# BURLINGTON RESOURCES

RE: Burlington Resources Compressor Station Site Inspections 2000. Manzanares GW-05, Gobernador GW-056, Pump Mesa GW-148, Quinn GW-239, Sandstone GW-193, Rattlesnake GW-093, Buena Vista GW-255, Pump Canyon GW-057, Hart Canyon GW-058, Cedar Hill GW-258, and Middle Mesa GW-07:

New Mexico Oil Conservation Division (OCD) conducted site inspections of 11 Burlington Resource's (BR) compressor stations that have discharge plan permits. Subsequent to these inspections OCD provided a list of inspection recommendations.

**RATTLE SNAKE COMPRESSOR STATION  
TANK WATER TANK REMEDIATION AND  
REPLACEMENT**

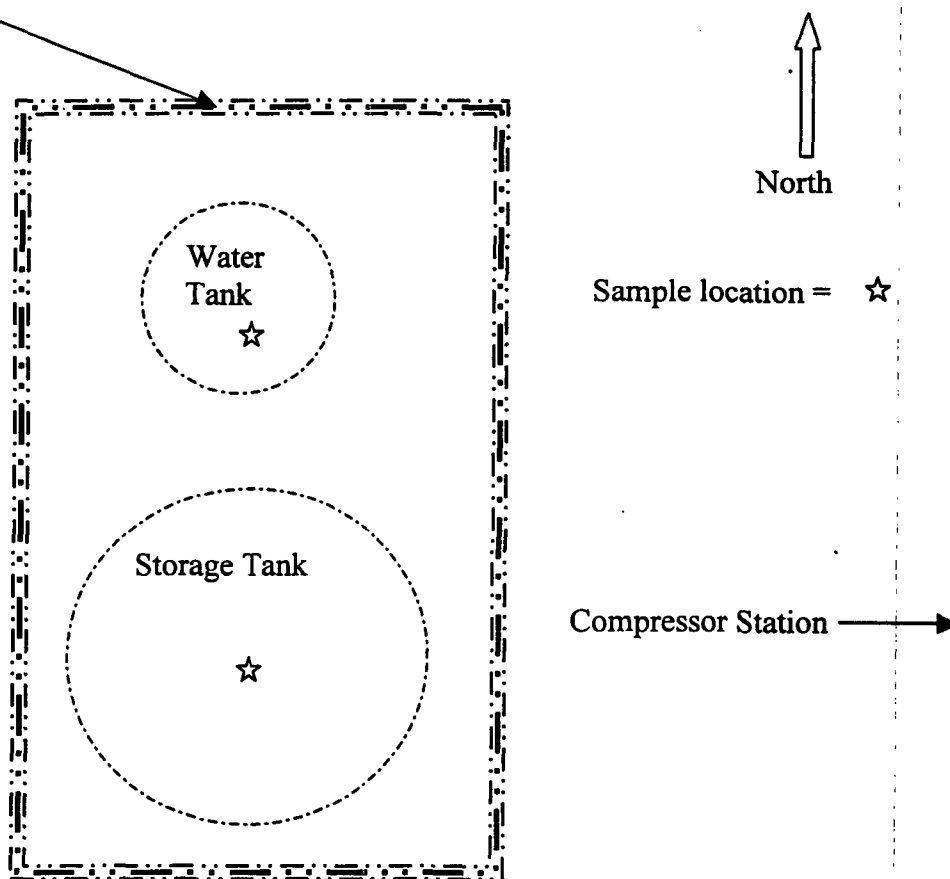
1. Motor oil and anti-freeze storage tanks do not have proper containment. *Containments under both tanks were upgraded to meet OCD's requirements.*
2. Oil and water observed in condensate underground wastewater storage tank leak detector. *The fiberglass wastewater storage tank was removed and replaced with a new metal tank. The condition of the fiberglass tank was satisfactory with no evidence of leaking. Historic contamination was detected adjacent to the wastewater tank and followed under the condensate storage tank during the excavation process. The source of the contamination was believed to be the storage tank. A laboratory sample for clean closure conformation was collected under this tank. The extent of contamination was determined to be limited to the extent of the bermed containment encompassing both storage tanks, approximately 20 feet x30 feet and 16 feet in depth at the deepest point. The impacted soils were removed and land farmed at the Quinn Compressor Station. The excavation was backfilled with clean soils and the facility was rebuilt. A diagram of the excavation and analytical results are included in Attachment 2.*

1. Area under both tanks excavated following the extent of soil contamination staining
2. Samples were collected at the deepest point of contamination under each tank.
3. The contamination was confined to area within berm perimeter (20 feet x 30 feet) and to a maximum depth under the storage tank of 16 feet.
4. Soil was replaced with clean fill and compacted and new water tank and the old storage tank were placed on liners and a berm reconstructed
5. Contaminated soil was land farmed at Quinn Compressor Station location

Sample from Water Tank collected at 8 feet PID field reading 0.0 ppm

Sample from Storage Tank collected at 16 feet BTEX = < 50 ug/kg  
DRO/GRO = <30 ug/kg  
PID = 0.0 ppm

GROUNDWATER MONITORING WELLS  
BUENTA VISTA COMPRESSOR STATION  
SAN JUAN COUNTY, NEW MEXICO

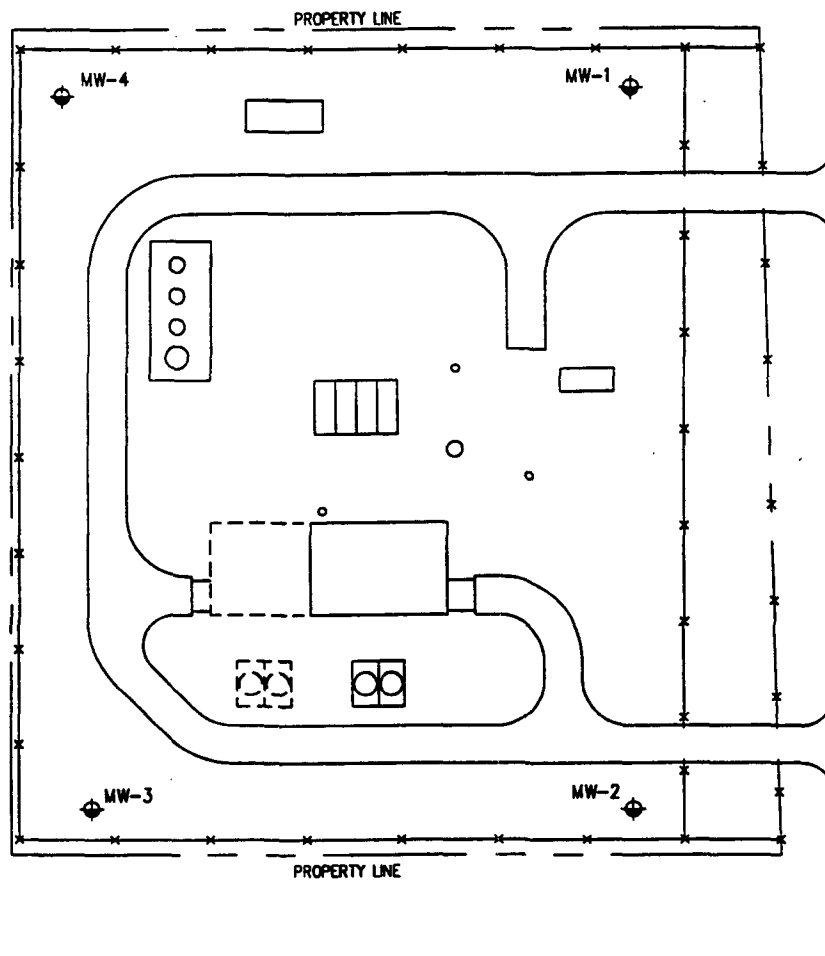
Submit most recent analysis from monitoring wells. *The most recent ground water monitoring analysis is provided in Attachment 3. Ground water samples were collected quarterly between 5/96 and 5/98 with no constituents of concern detected. Included in the attachment is a letter from BR to BLM (June 25, 1998) recommending the four wells for plugging and abandonment.*
